**Re: EA0708-007 Taltson Hydroelectric Expansion Project:
Parks Canada Final Submission**

**Parks Canada Agency
Final Submission:
Mackenzie Valley Review Board EA0708-007
Taltson Hydroelectric Expansion Project – Dezé Energy Corp.
May 10, 2010**

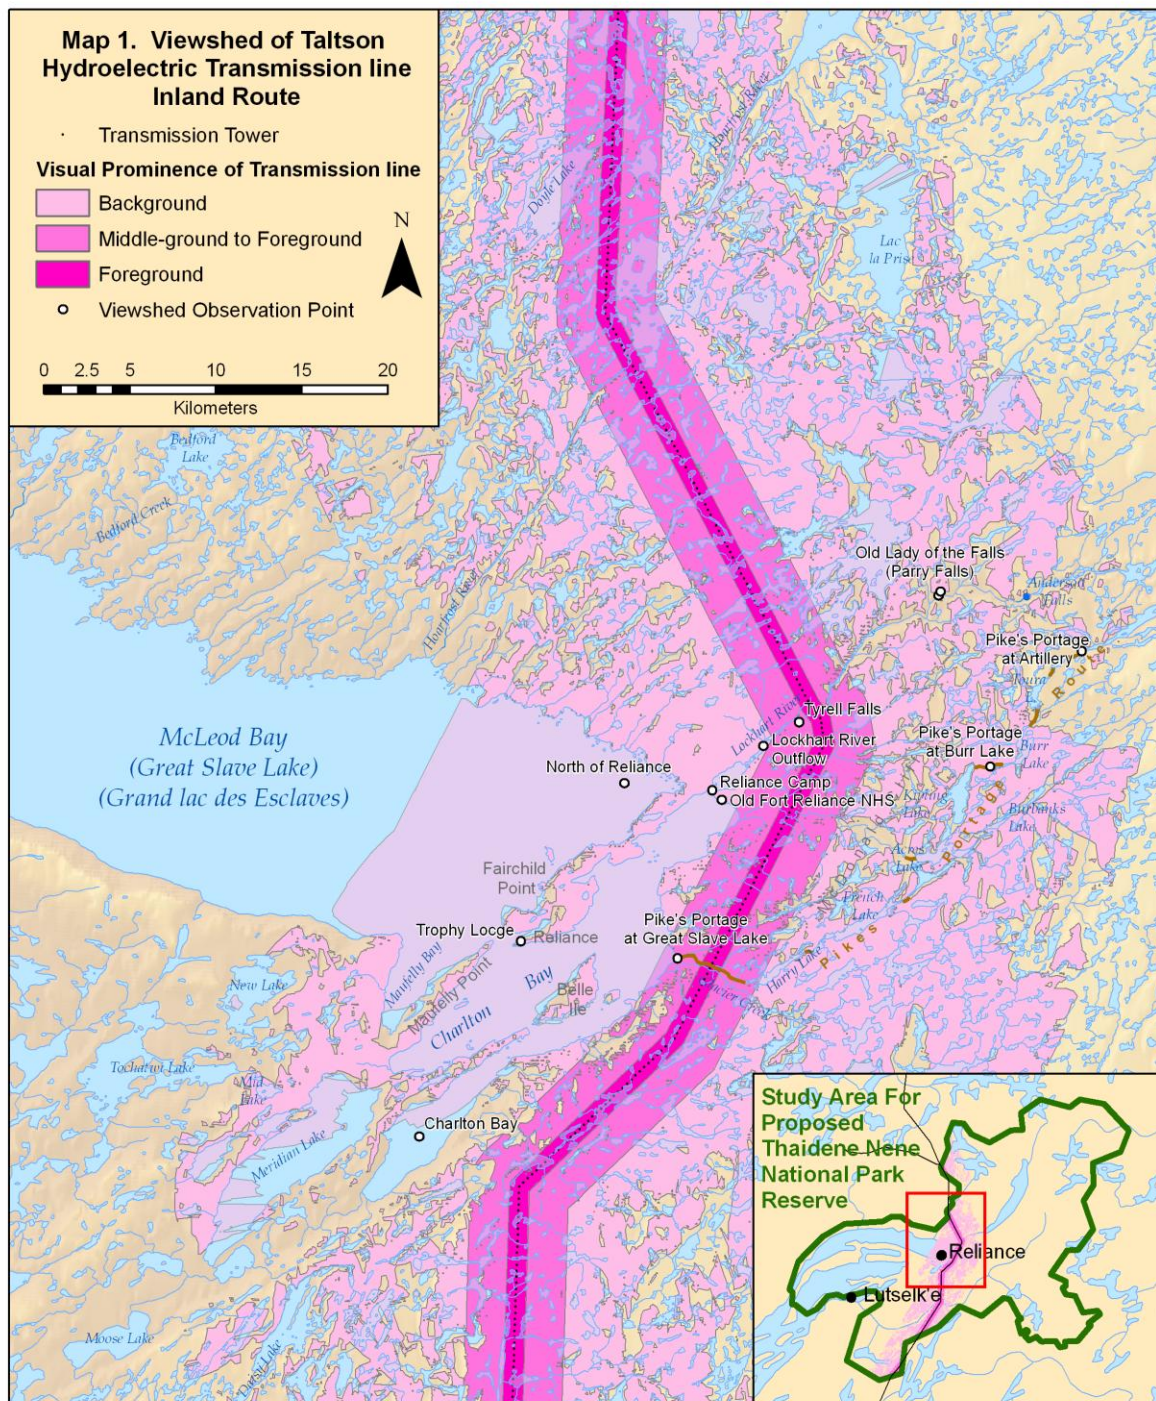
In addition to the above analysis, Parks Canada further analyzed the routes using a methodology that examined the extent to which an object fills an observer's field of view.⁷ The results are presented in Maps 1 and 2, illustrating the relative impact of the route alternatives in the proposed Thaidene Nene National Park Reserve. The maps identify where the line may be expected to be visible in the background, where the line would be visible in the middle-ground to foreground, and where the line would be visually prominent in the foreground. This information is also incorporated into Table 1 for the key viewpoints considered in the earlier analysis.

The maps illustrate that the adverse visual impacts of the Reliance Adjustment are greater than for the proposed Inland Route at key viewpoints. For the Inland Route, the line is visually prominent (seen in the middle-ground to foreground) at only one location (Pike's Portage at Great Slave Lake), and is visible in the background at four viewpoints. A line following the Reliance Adjustment would be visually prominent at five locations (Old Fort

It should also be noted that almost all visitors to the proposed Thaidene Nene National Park Reserve will likely approach and enter the park via Great Slave Lake. The maps illustrate that a transmission line that crossed from Maufelly to Fairchild Point, even where the crossing was underwater, would at one time or another be in the foreground of the field of view for essentially all visitors. Although a transmission line following the Inland Route would also be visible from Great Slave Lake, it would be much less prominent in the visitor's field of view.

The maps also illustrate that small changes in the transmission line routing, or in location of a viewpoint, could mean the difference between no visual impact and a moderate or even high impact. Note for instance, that for the Inland Route, no towers are visible at Parry Falls or Trophy Lodge. A close look at the map, however, indicates that a relatively small change in observer location could bring the line back into view. Final route selection must take this into careful consideration.

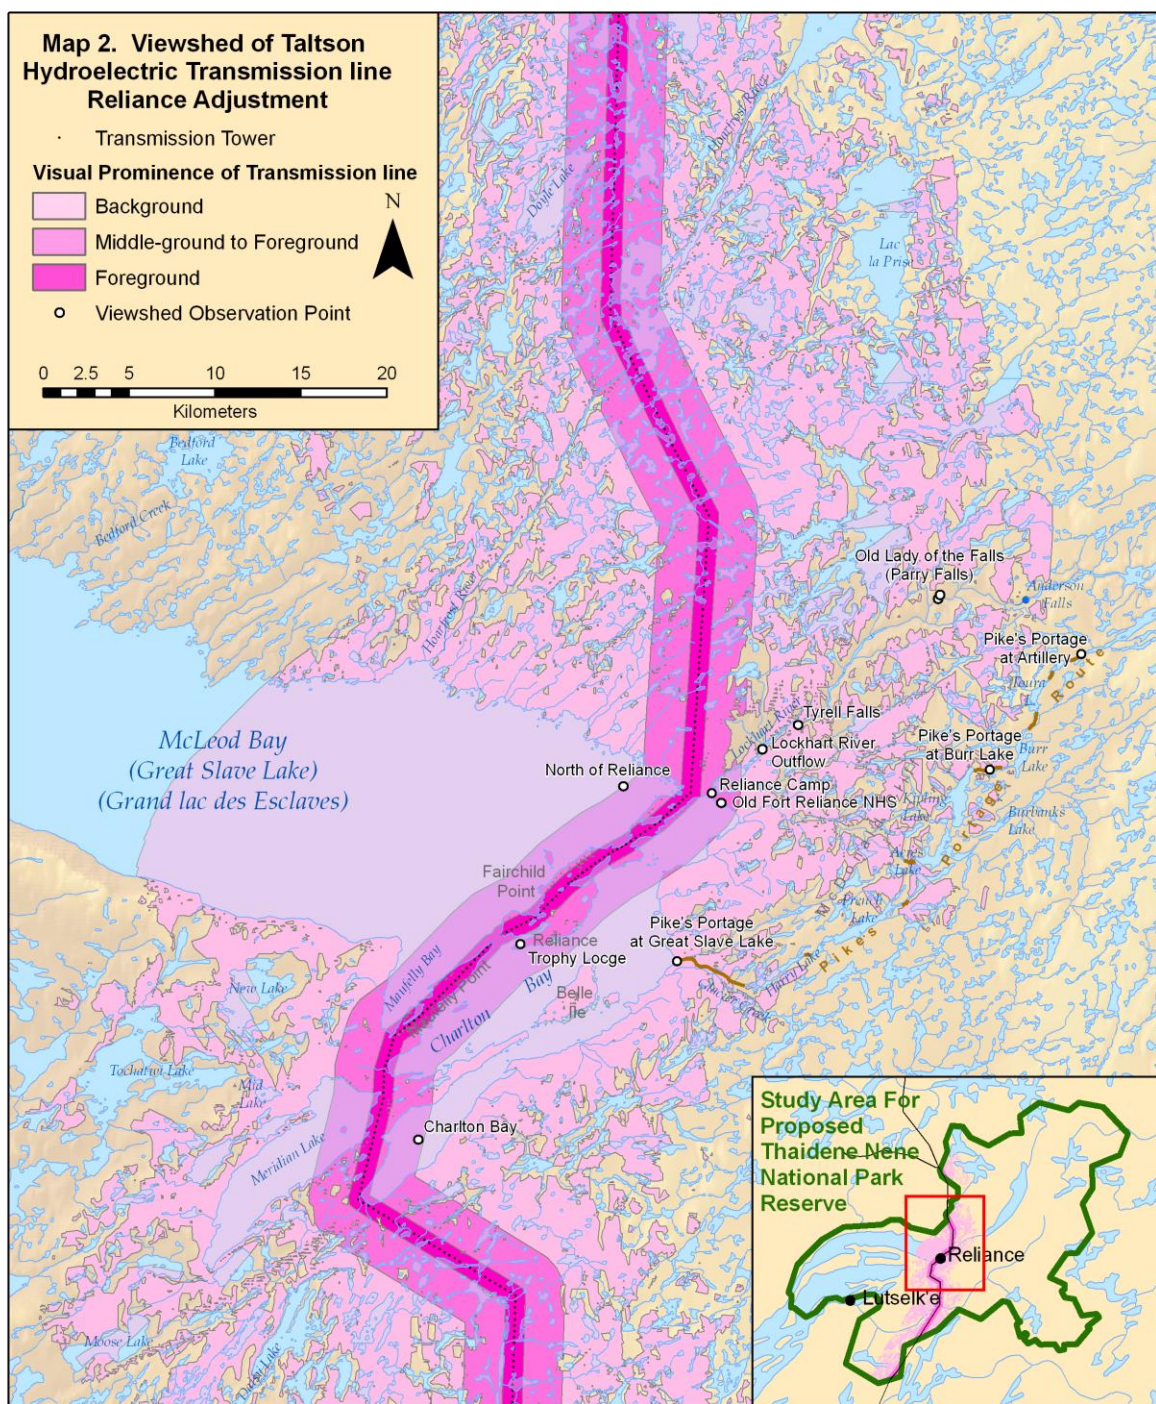
The visual analysis indicates that the Reliance Adjustment route of the transmission line is located in the "foreground to middle-ground" of an observer's field of view at Fort Reliance National Historic Site. This would have an adverse effect on the commemorative integrity of the site, disturbing the view across the Lake. Though there is also an adverse visual effect on Fort Reliance NHS from the Inland Route, this would appear in the background. It is also in the east, and away from Great Slave Lake, with no consequential impact to the commemorative integrity of the site.
